Department of Energy
Idaho Operations Office
1955 Fremont Avenue
Idaho Falls, ID 83401

SUBJECT: Supplemental Responsiveness Summary for the Action Memorandum for Accelerated Retrieval of a Described Area within Pit 4 (FMDDP-FFA/CO-04-011)

Supplemental Responsiveness Summary for the Action Memorandum for Accelerated Retrieval of a Described Area within Pit 4

Figure 1. Diagram of the general process flow and disposal logic for major waste streams resulting from the Accelerated Retrieval Project.

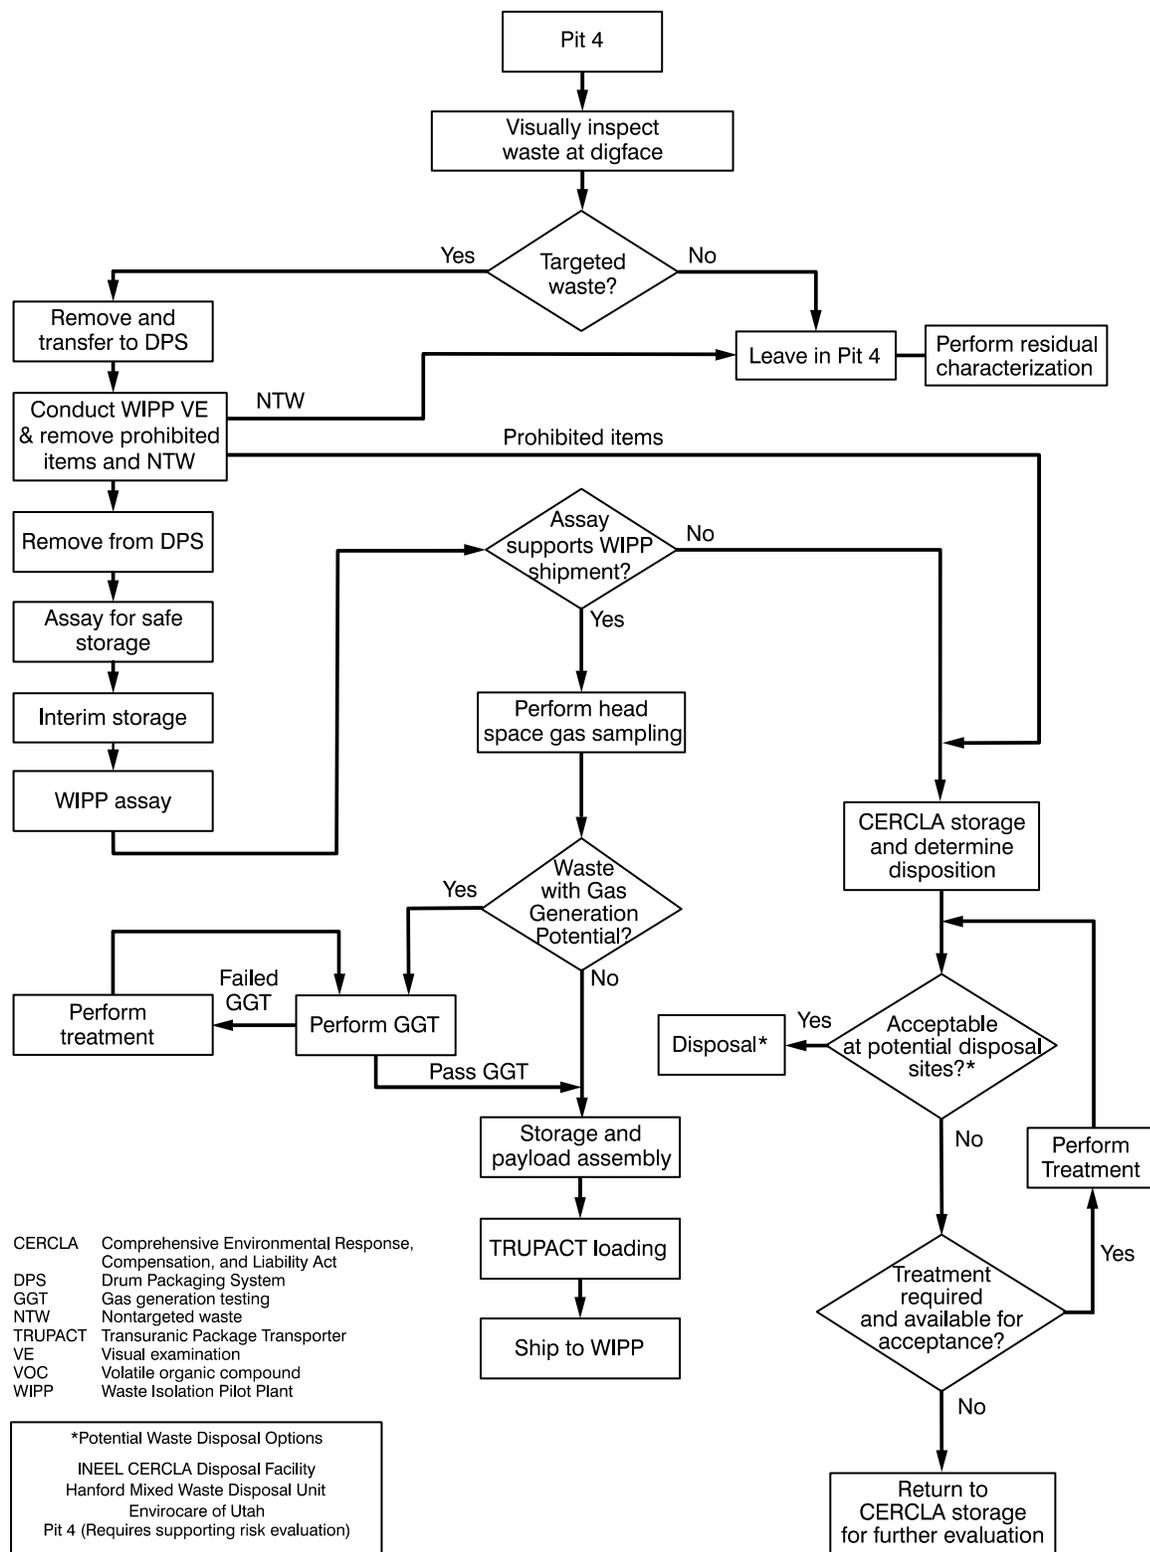
Topic #6: Public concern was expressed about the ability to transfer waste to WIPP and what will happen to waste that is not eligible for disposal at WIPP.

Topic #7: Public concern was expressed about compliance with legal requirements such as Resource Conservation and Recovery Act (RCRA) (42 USC § 6901 et seq., 1976) land disposal restrictions, the dense-pack drum storage arrangement, and Toxic Substances Control Act (TSCA) (15 USC § 2601 et seq., 1976) requirements for polychlorinated biphenyl (PCB) management.

Response: The project is actively working with WIPP officials to ensure retrieved TRU waste meets WIPP requirements. Retrieved targeted waste forms will be visually examined for compliance with WIPP

requirements during repackaging at the drum-packaging station. The waste will be placed in safe and compliant storage until additional characterization steps (e.g., assay and headspace gas sampling) can be performed. Alternative disposal options are currently being evaluated for waste that does not qualify for disposal at WIPP. The diagram presented in Figure 1 illustrates the general process flow and disposal logic for major waste streams resulting from the AR Project.

At the suggestion of a commenter, a generalized process flow chart (see Figure 1) has been developed to illustrate the major process steps, associated decision points, and potential waste disposal options that are being evaluated as part of the proposed action.
